Figure 7B-1. Signs in School Areas and at School Crossings (Sheet 1 of 2)

Summary of Comments on CAMUTCD 2026 7B Fig.pdf

Figure 7B-3. Example of Signing for a School Crossing Outside of a School Zone

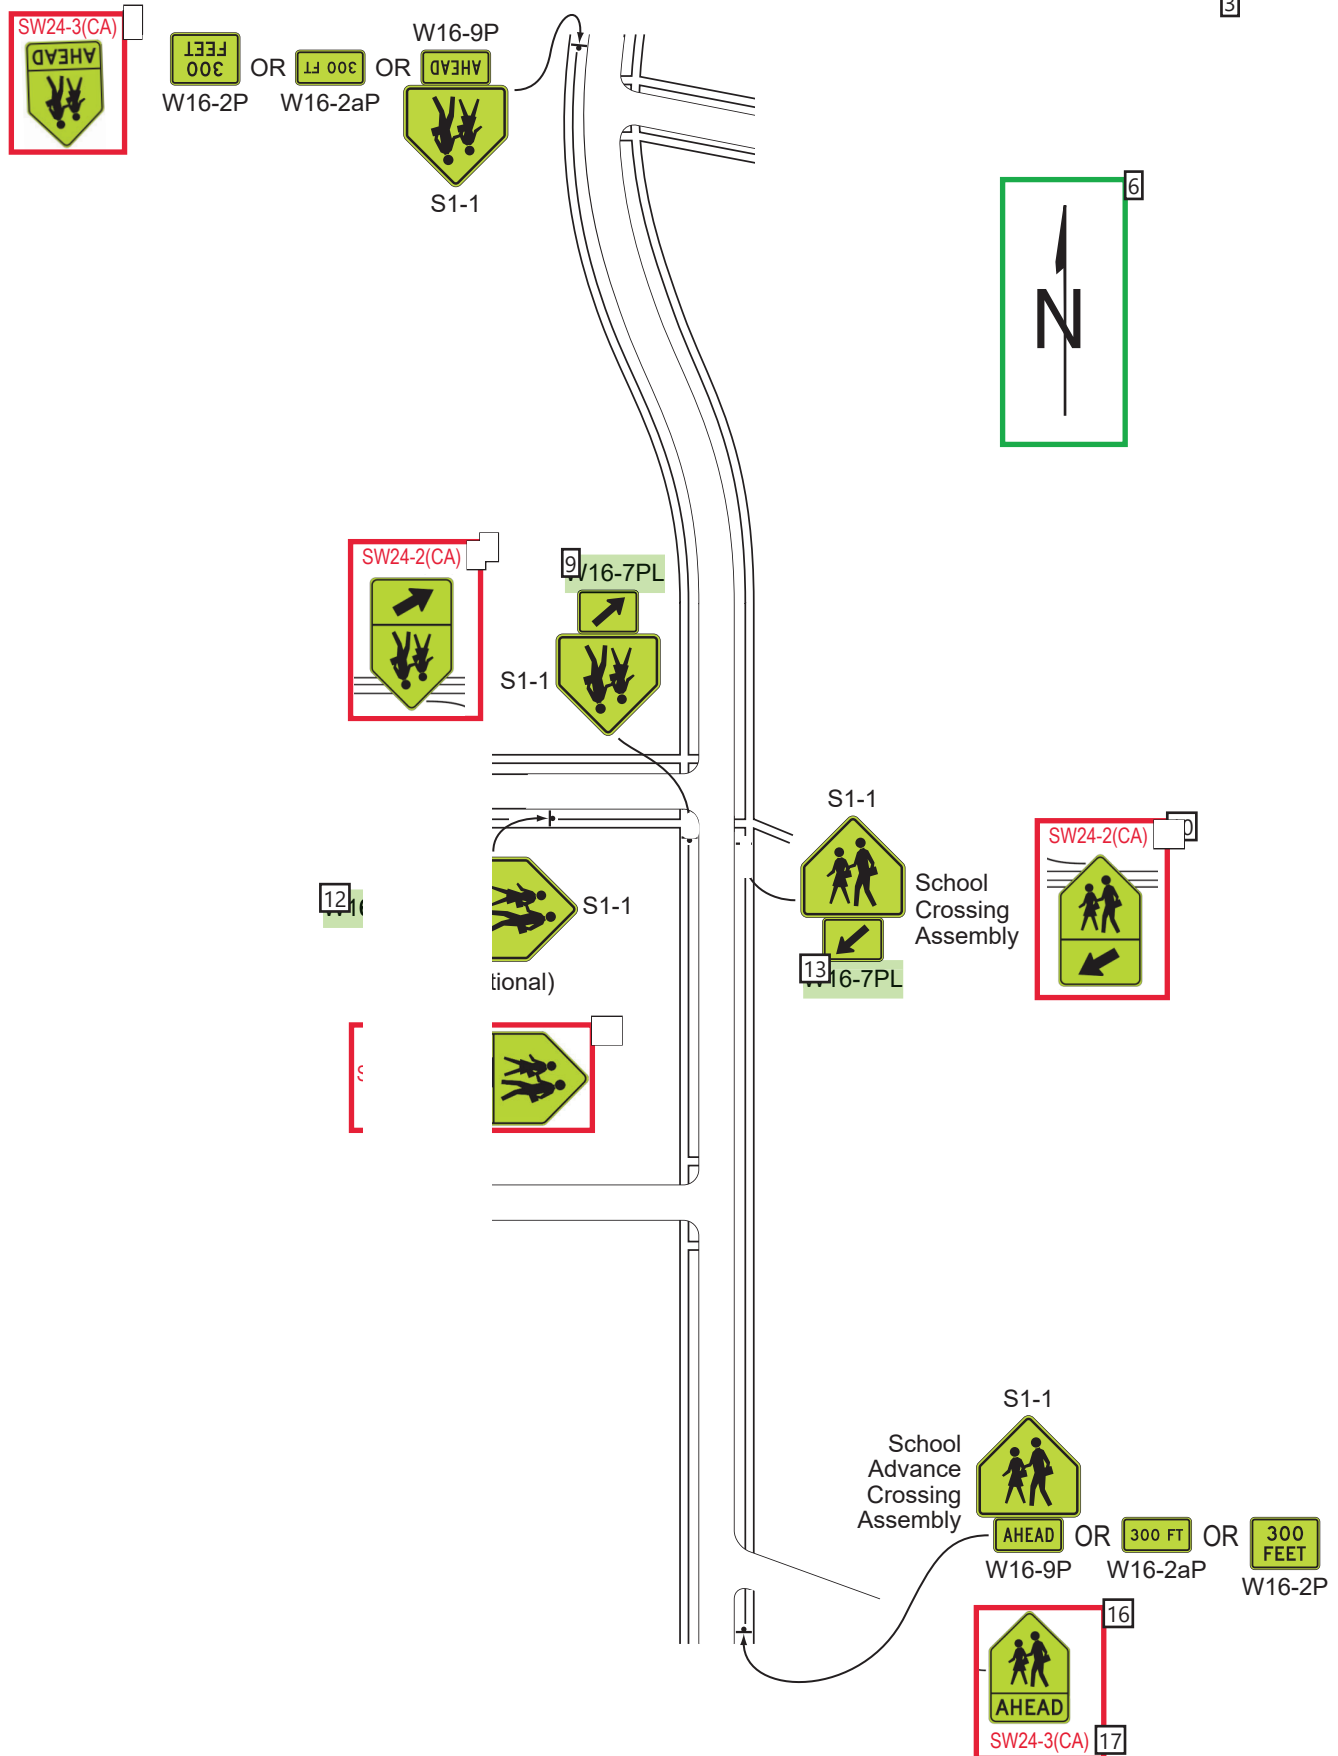
-
- Number: 1 Author: s116730 Subject: Highlight Date: 7/25/2024 9:49:29 AM
Options for CA signs that are combined with plaques (for all signs shown on this sheet) will be added

- NMUTCD 2023 added sign codes for all signs, which were missing in NMUTCD 2009 figures
-
- Number: 2 Author: s116730 Subject: Highlight Date: 7/25/2024 9:49:32 AM
NMUTCD 2023 changed NMUTCD 2009 Figure 7B-4 to 7B-3 and added sign codes for the signs shown in the figure.
-

- Number: 3 Author: s116730 Subject: Text Box Date: 7/10/2024 3:11:55 PM
-
- Number: 4 Author: s116730 Subject: Rectangle Date: 7/10/2024 3:20:12 PM
Add SW24-3(CA) Assembly D(CA) image
-

- Number: 7 Author: s116730 Subject: Rectangle Date: 7/10/2024 3:21:59 PM
Add SW24-2(CA) Assembly B(CA) image
-
- Number: 8 Author: s116730 Subject: Text Box Date: 7/10/2024 2:59:39 PM
SW24-2(CA)
-

- Number: 9 Author: s116730 Subject: Highlight Date: 7/25/2024 9:49:59 AM
NMUTCD 2023 changed the NMUTCD 2009 sign code "W16-7P" to "W16-7PL"
-
- Number: 10 Author: s116730 Subject: Rectangle Date: 7/10/2024 3:21:47 PM
Add SW24-2(CA) Assembly B(CA) image
-

- Number: 11 Author: s116730 Subject: Text Box Date: 7/10/2024 3:00:31 PM
SW24-2(CA)
-
- Number: 12 Author: s116730 Subject: Highlight Date: 7/25/2024 9:50:05 AM
NMUTCD 2023 changed the NMUTCD 2009 sign code "W16-6P" to "W16-6PR"
-

- Number: 13 Author: s116730 Subject: Highlight Date: 7/25/2024 9:50:09 AM
NMUTCD 2023 changed the NMUTCD 2009 sign code "W16-7P" to "W16-7PL"
-
- Number: 14 Author: s116730 Subject: Rectangle Date: 7/10/2024 3:23:06 PM
Add SW24-1(CA) Assembly A(CA) image
-

- Number: 15 Author: s116730 Subject: Text Box Date: 7/10/2024 3:05:01 PM
SW24-1(CA)
-
- Number: 16 Author: s116730 Subject: Rectangle Date: 7/10/2024 3:22:25 PM
Add SW24-3(CA) Assembly D(CA) image
-

Figure 7B-4. Example of Signing for a School Zone with a School Speed Limit and Higher Fines Only for Speeding

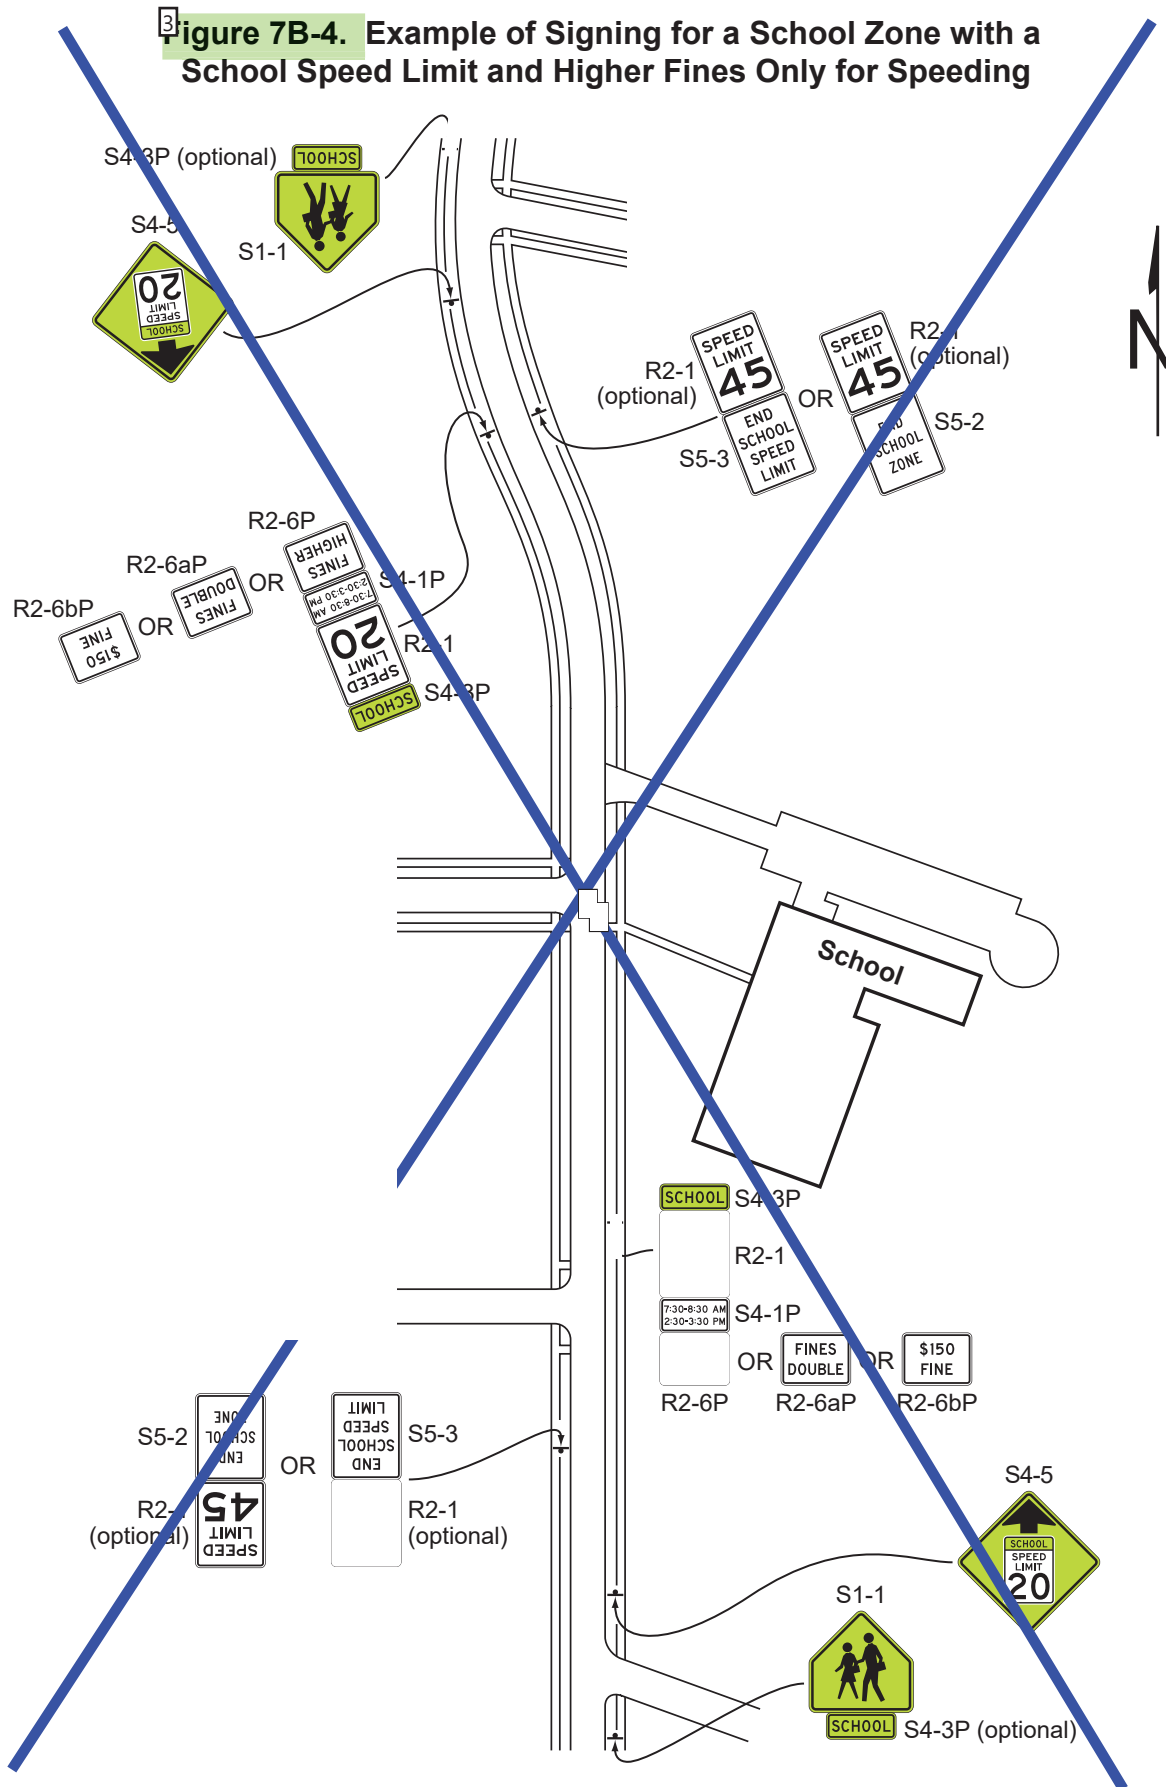
NMUTCD 2023 changed NMUTCD 2009 Figure number 7B-3 to 7B-4 and made other minor changes in the figure. This figure was shown in CA MUTCD 2014R8 with a blue "X".NMUTCD 2023 Figure 7B-4 is shown in CA MUTCD 2026 with a blue "X"

Since this figure is not applicable in CA, specific changes made in NMUTCD 2023 have not been identified.

Figure 7B-5. Example of Signing for a School Zone with Higher Fines for All Traffic Violations (Sheet 1 of 2)

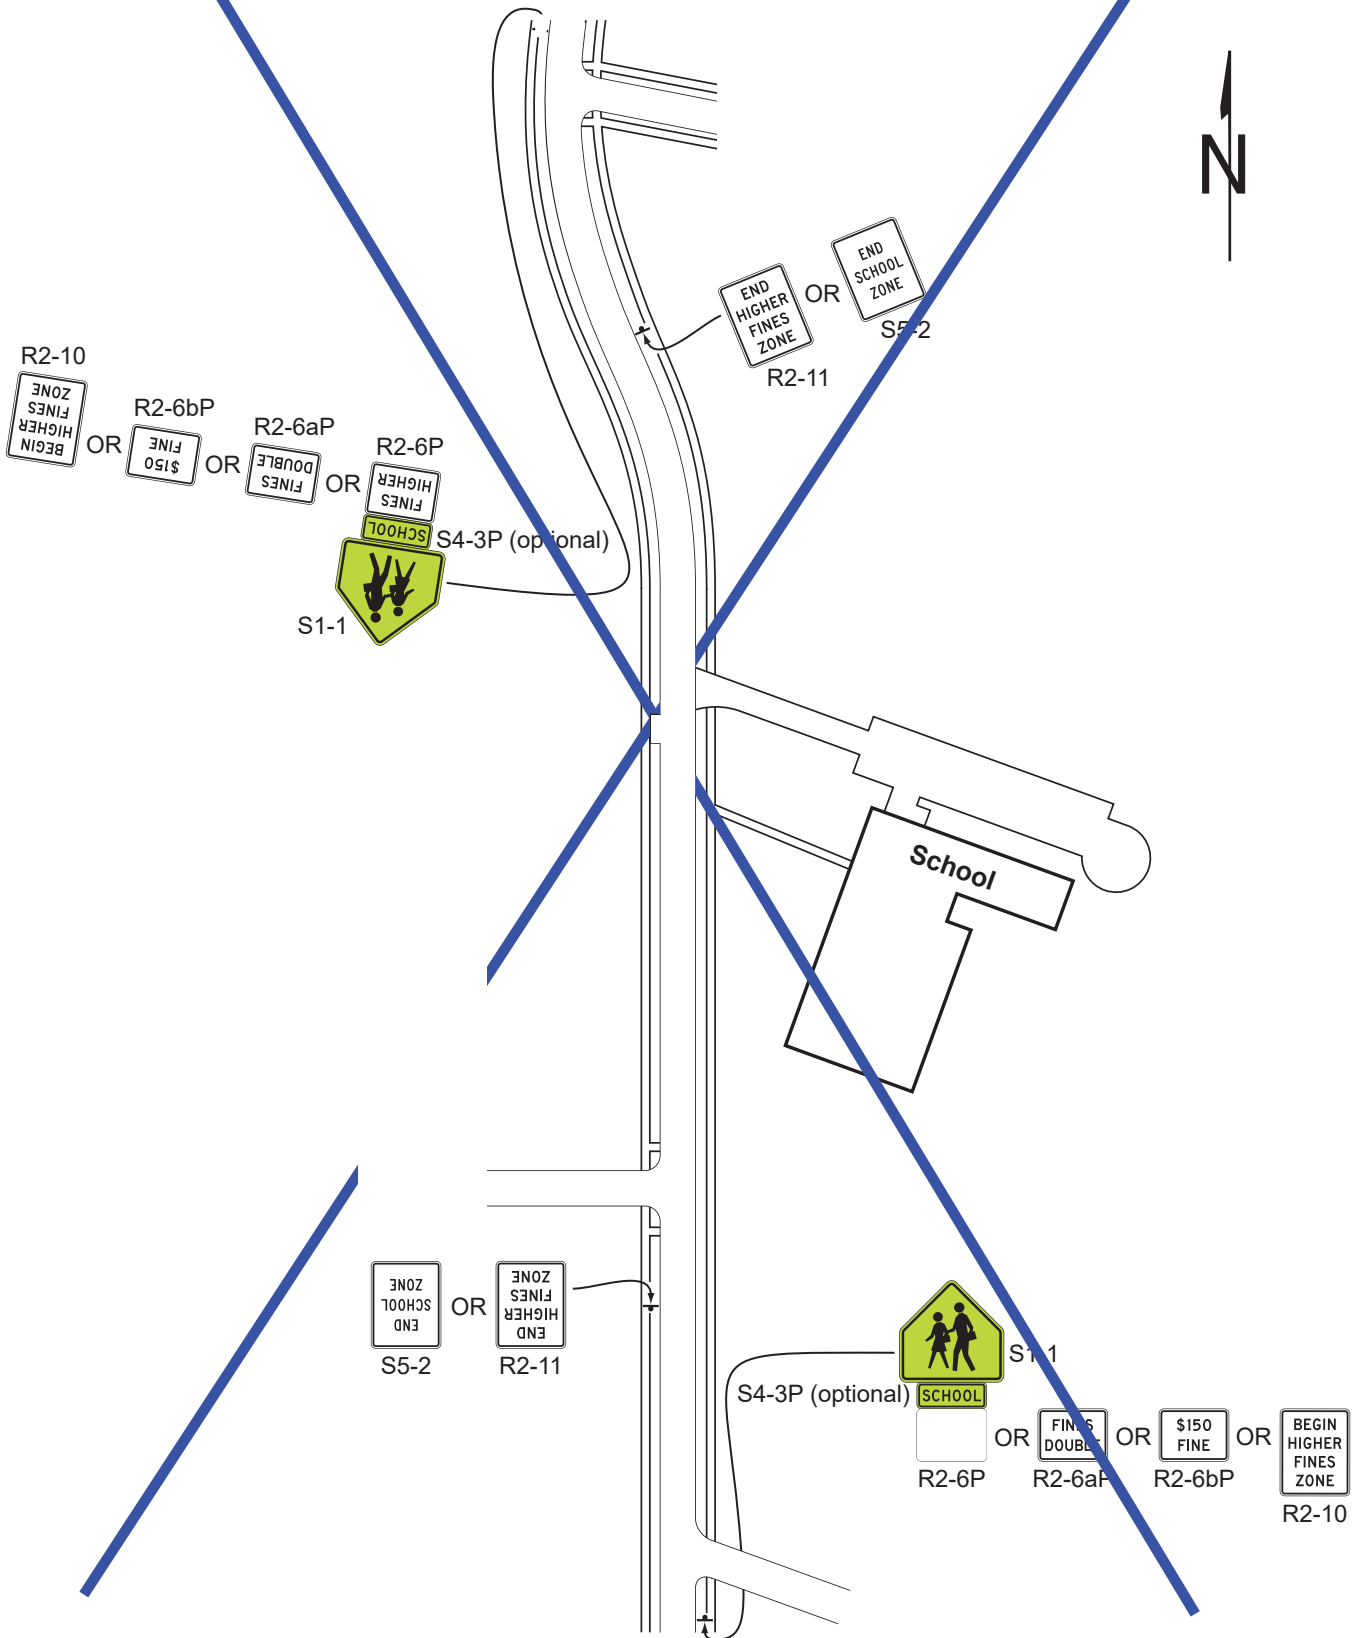
NMUTCD 2023 changed NMUTCD 2009 Figure number 7B-2 to 7B-5 (Sheets 1 and 2 of 2) and made other minor changes in the figure. NMUTCD 2023 Figure 7B-5(Sheet 1 of 2) is shown in CA MUTCD 2026 with a blue "X"

Figure 7B-5. Example of Signing for a School Zone with Higher Fines for All Traffic Violations (Sheet 2 of 2)

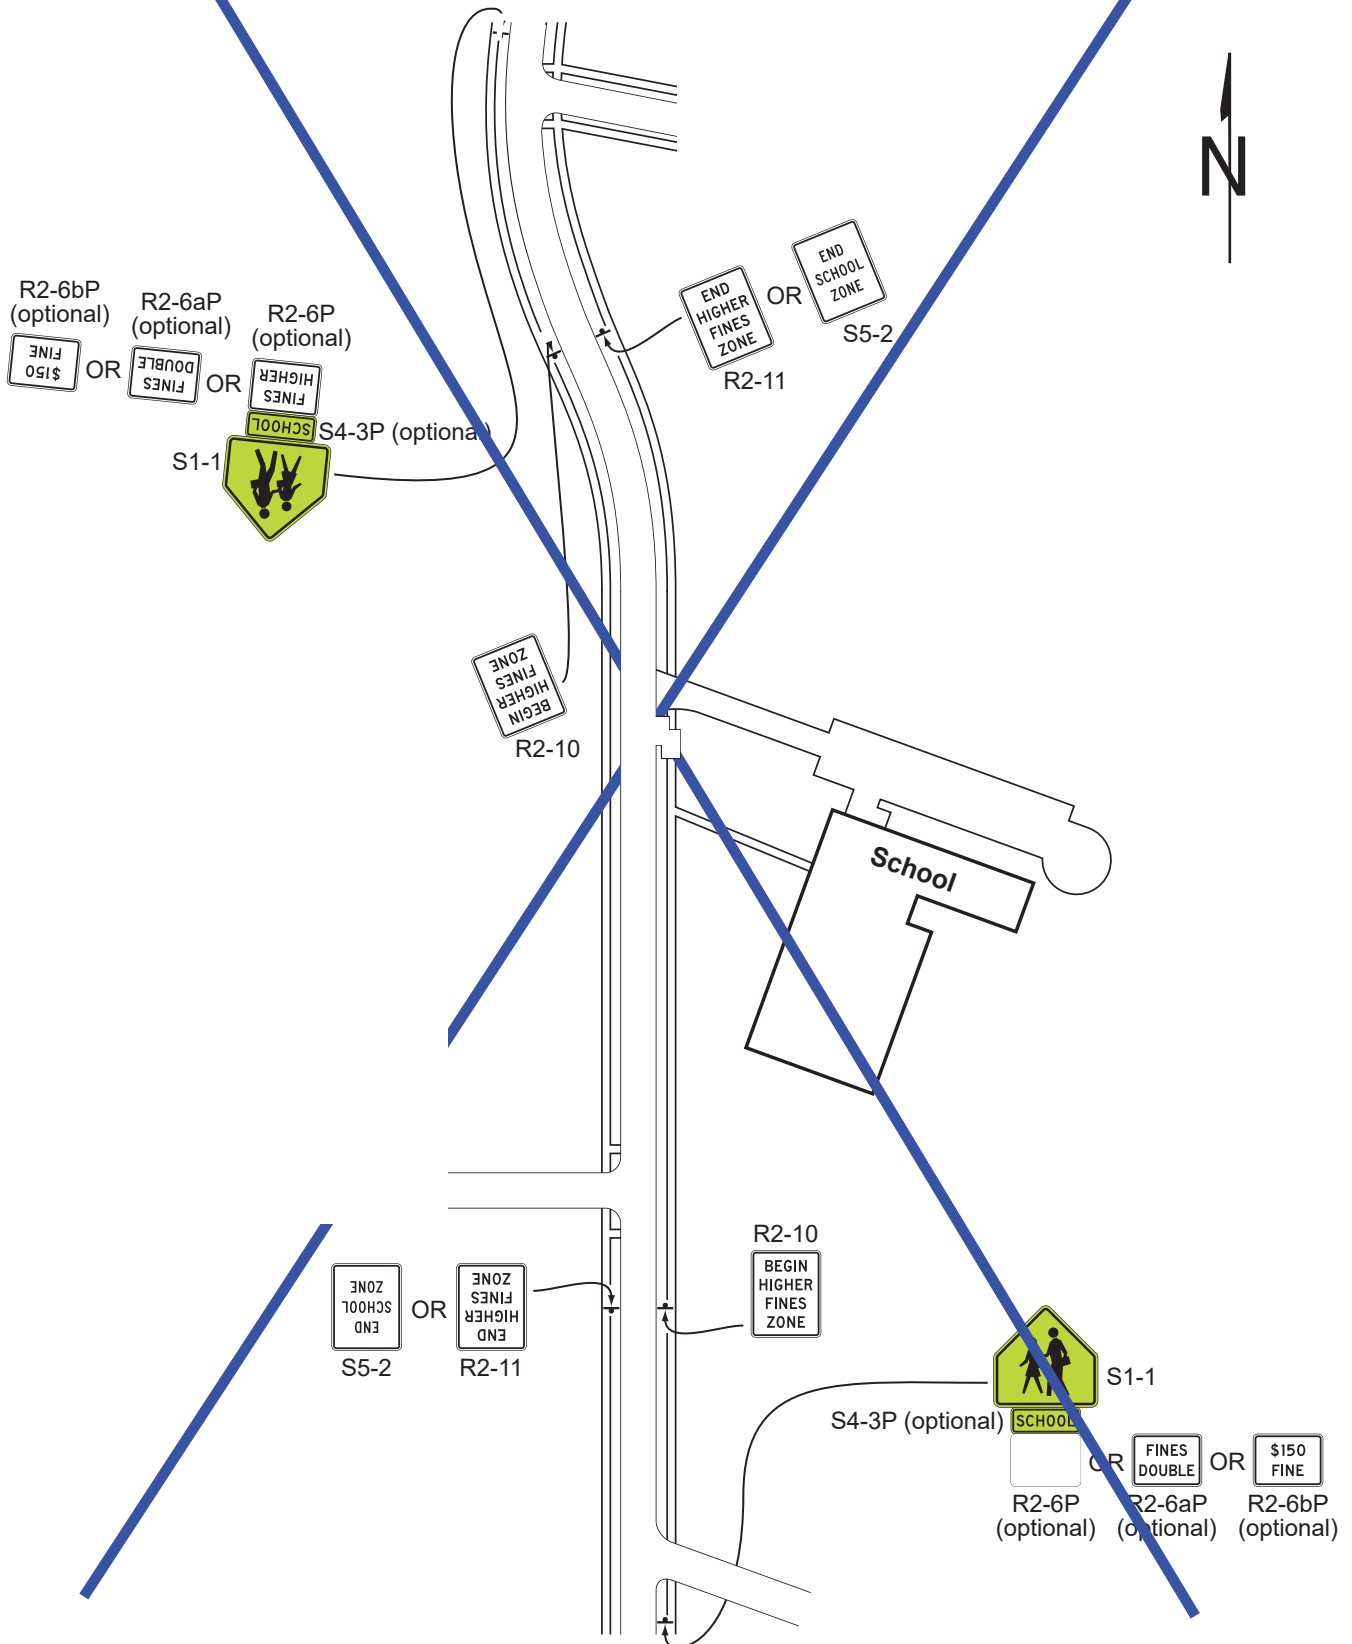
Number: 3 Author: s116730 Subject: Highlight Date: 7/25/2024 9:50:31 AM
NMUTCD 2023 changed NMUTCD 2009 Figure number 7B-2 to 7B-5 (Sheet 1 and 2 of 2) and made other minor changes in the figure.
NMUTCD 2023 Figure 7B-5(Sheet 2 of 2) is shown in CA MUTCD 2026 with a blue "X"
